DNS: EIA Scoping Direction

CAS-02084-T4Z8W4 - Hirfynydd Renewable Energy Park

Planning and Environment Decisions Wales (PEDW) received a request under [Regulation 33](#) of the 2017 Regulations for a Scoping Direction in relation to a proposed development for a ‘Renewable energy park comprising wind generating capacity, solar photovoltaic generating capacity, battery storage and associated infrastructure’ by EDF Renewables (‘the Applicant’).

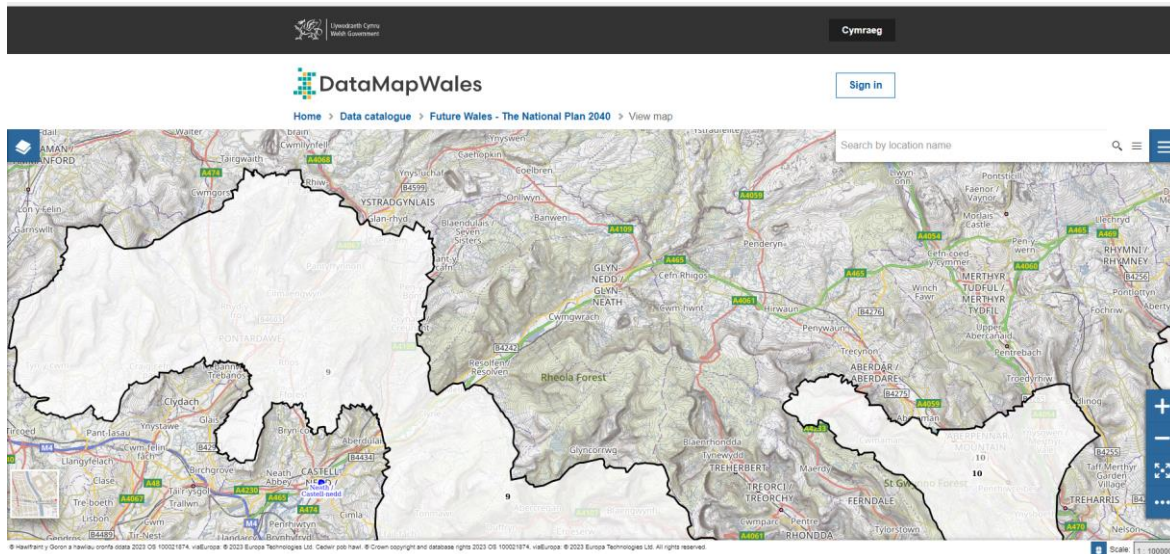
The application site is clearly outside of the pre-assessed wind areas identified within Future Wales, as illustrated in the map below:

Application of national planning policy therefore falls primarily to the criteria contained within Policy 18. There is no presumption in favour of landscape change, as would be the case for sites located within pre-assessed wind areas that are subject to Policy 17.

From 2005 the previous national planning policy for onshore wind development was based on Technical Advice Note ('TAN') 8. This defined a series of strategic search areas ('SSAs') and the proposed site lay within Area E. It is therefore notable that the site has now been excluded from the Policy 17 pre-assessed area.
